U.S. Department  
of Transportation  
**Federal Highway  
Administration**

JUN 29 1990

By your September 16 and 22, 1988, letters to Mr. Thomas O. Willett, Director, of Office of Engineering, you requested Federal Highway Administration (FHWA) acceptance of steel breakaway slip-base luminaire supports for use on Federal-aid highway projects. As you know, considerable effort has gone into evaluating steel slip-base luminaire supports since you made your request. Your cooperation and assistance in that effort is much appreciated. Enclosure I summarizes the tests FHWA has evaluated in reaching a decision on the breakaway acceptability of steel slip-base luminaire supports.

Subject: Slip-Base Luminaire Supports

Luminaire Slip Base Orientation

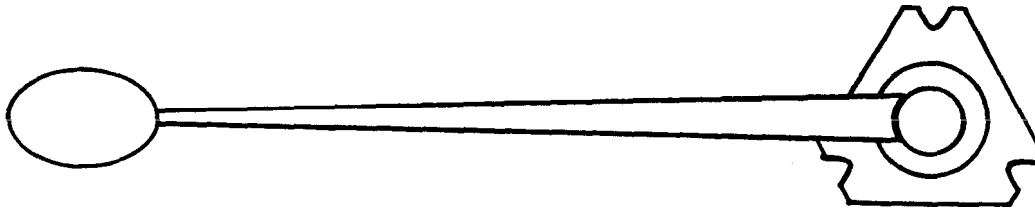
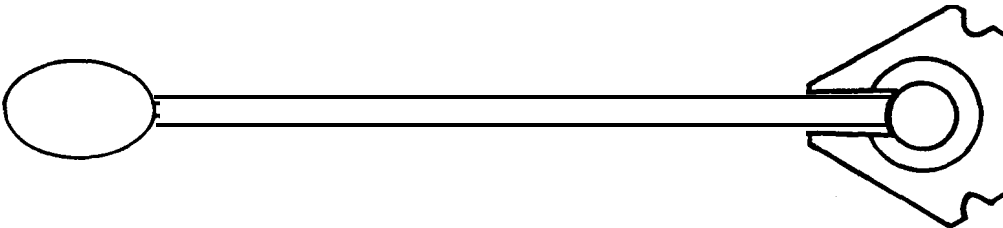
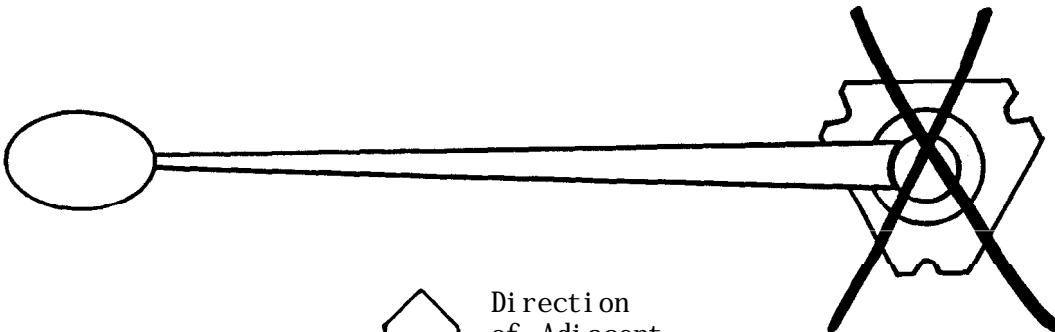
Mast Arm Orientation: Mast arm may be parallel to a flat side of the base provided that side faces approach traffic or may pass over a clamp bolt (see Enclosure III.)

Best Breakaway  
Performance  
Acceptable

Best Compromise  
to avoid undesirable  
orientation  
Acceptable

Worst Breakaway  
Performance  
Not Recommended

Luminaire Slip Base Orientation

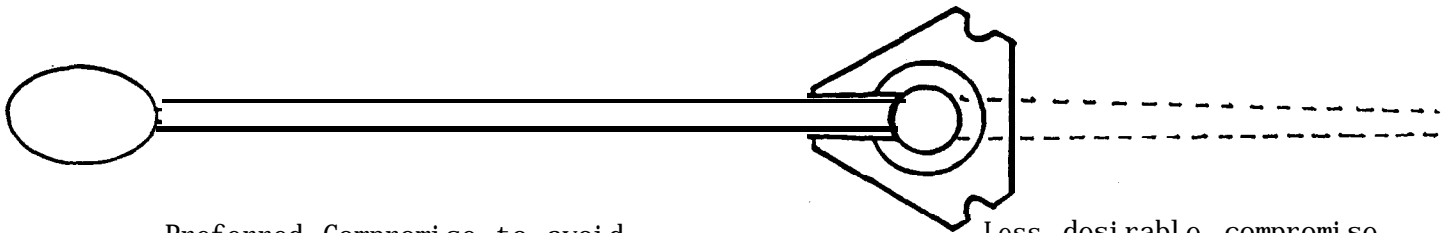
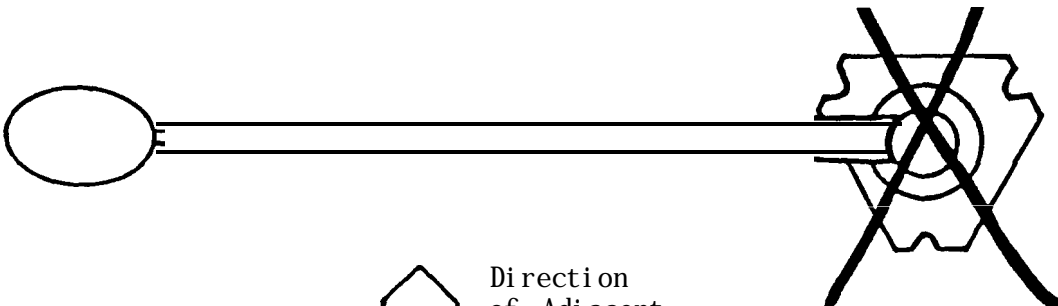
Our July 6, 1990, memorandum "Breakaway Sign and Luminaire Supports," transmitted a sketch titled "Luminaire Slip-Base Orientation." This sketch illustrated three ways that the triangular slip-base could be welded to the pole with respect to orientation of the mast arm. These were shown in decreasing order of preference with respect to crashworthiness. We have had questions regarding the middle sketch, which showed an acceptable compromise situation where the far side of the triangular slip-base was parallel to traffic. Although our memorandum did not address the situation where the orientation of the triangular slip-base is such that the near side is parallel to traffic, it is an acceptable, though less desirable, compromise. A revised copy of that sketch is attached to show that traffic may **pass to either side of a slip-base where one face is parallel to the edge of the road..**

**Best Breakaway  
Performance,  
Acceptable**

Preferred Compromise to avoid  
Undesirable orientation, Acceptable

Less desirable compromise,  
Acceptable

**Worst Breakaway  
Performance,  
Not Recommended**
